## SEISMIC WALKDOWN CHECKLIST FORM

Status: Y  N  U Seismic Walkdown Checklist (SWC) SWEL2-008Equipment ID No. 19P-1A Equip. Class 5. Horizontal pumpsEquipment Description: Fuel pool cooling recirc pump ALocation: Bldg. RB Floor El. 326 Room, Area Col 3 line T

**Note:** *Unanchored Cabinets*

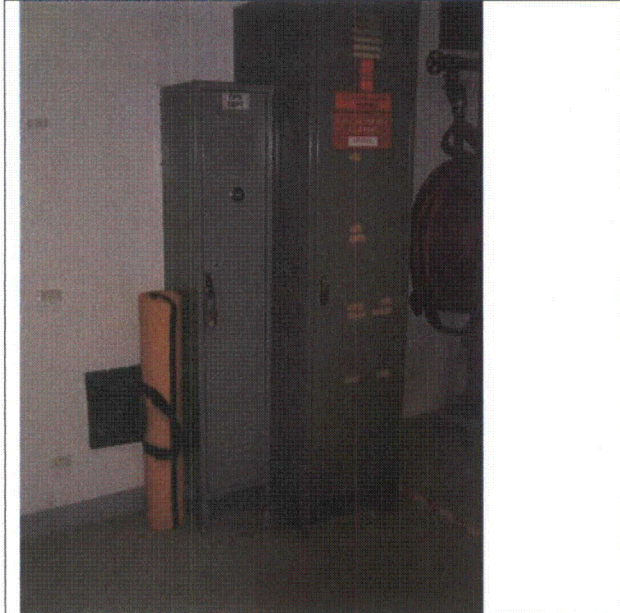
*Two cabinets in EDG-B/D switchgear room, do not seem to be anchor to the wall nor the floor. The plant personnel were notified. This is not a credible seismic interaction.*

**Note:** *Improper light hooks.*

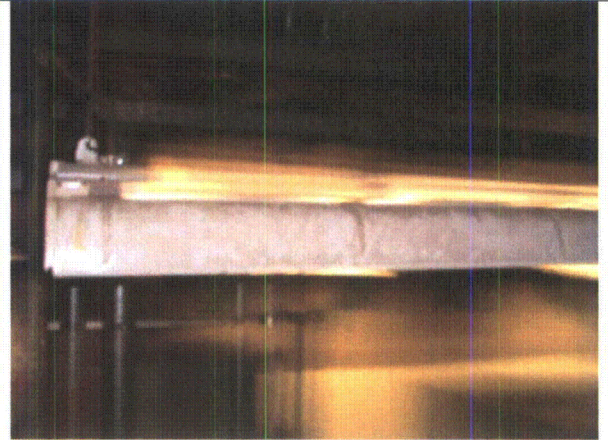
*Two lights next to Motor Control Centers (MCCs) do not have latches present on the hooks. In a seismic event one end may become unhooked and swing. For the fixture to hit the MCC, and out-of-plane motion is required which is very unlikely. Not a credible seismic event. The site personnel were notified immediately.*

Area Walk-By Checklist (AWC) AWC- 017

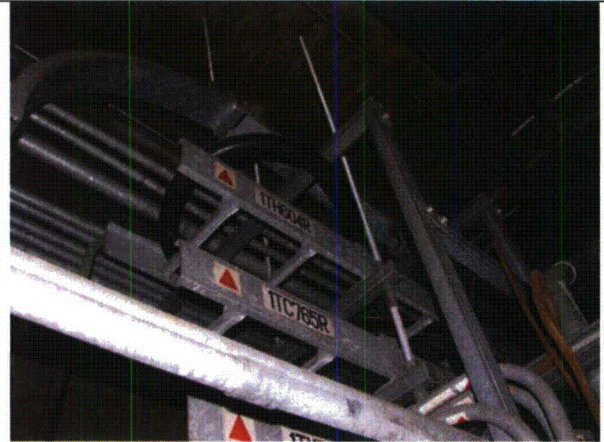
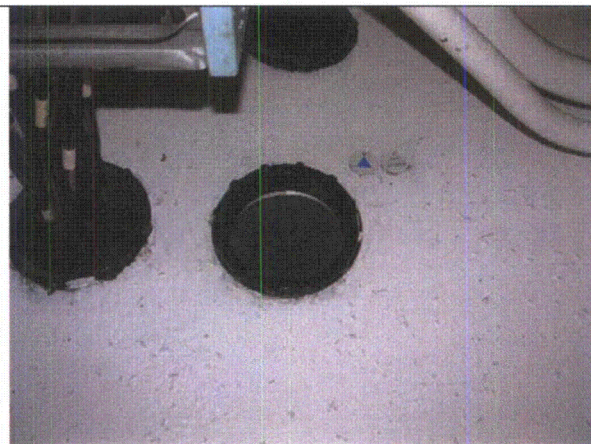
Comment Number	Section/Page No.	Review Comment	Response/Resolution	Reviewer's Accept Initials
85	AWC-017	The AWC title should be AWC-017 The SWEL components should be "SWEL1-XXX" Sheets 4,5: Caption should say "Photo" instead of "Illustration" Delete pp.6-8	- <i>Comment incorporated</i> - <i>Comment incorporated</i> - <i>Caption corrected.</i>	TP
86	AWC-018	The AWC title should be AWC-018 The SWEL components should be "SWEL1-XXX" Sheets 4: Caption should say "Photo" instead of "Illustration" Delete pp.5-8	- <i>Comment incorporated</i> - <i>Comment incorporated</i> - <i>Caption corrected.</i>	TP
87	AWC-021	The AWC title should be AWC-021 The SWEL components should be "SWEL1-XXX" Sheets 4: Caption should say "Photo" instead of "Illustration" Delete pp.5-8	- <i>Comment incorporated</i> - <i>Comment incorporated</i> - <i>Caption corrected.</i>	TP
88	AWC-022	The AWC title should be AWC-022 The SWEL components should be "SWEL1-XXX". Delete pp.5-8	- <i>Comment incorporated</i> - <i>Comment incorporated</i>	TP
